HIGH POINT PLANNING AREA 64

SITE PLAN 01

**HIGH POINT - PLANNING AREA 64**  
 SITE PLAN 01  
 CITY OF AURORA, COLORADO

DATE:  
 PP01-03/13/2020

**1 TREE PLANTING DETAIL**

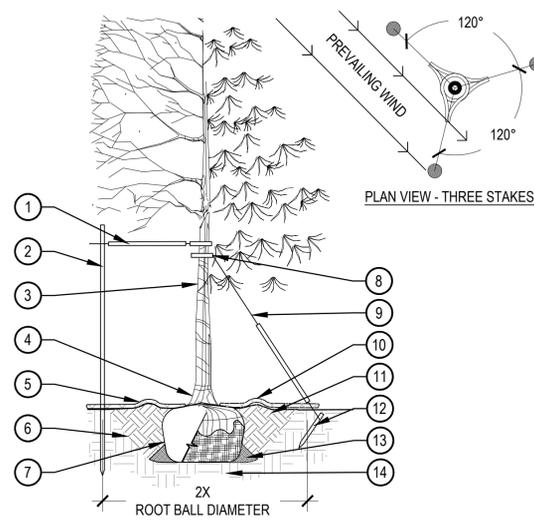
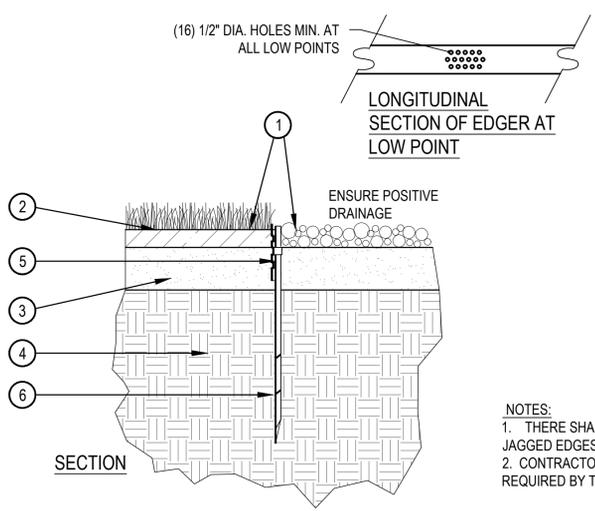
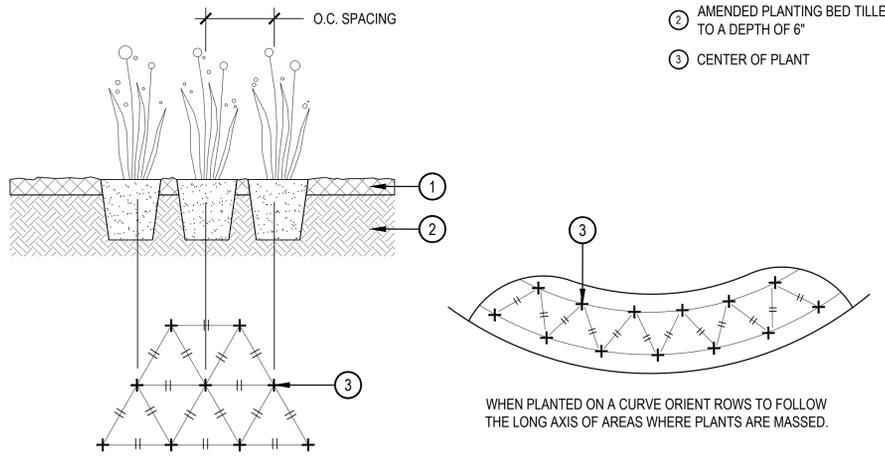
Include a detail for the proposed monument signage. The FDP currently under review, has examples but the actual proposed monument sign needs to be included here for review.

**Response:**  
 Monument signs have been removed from the project
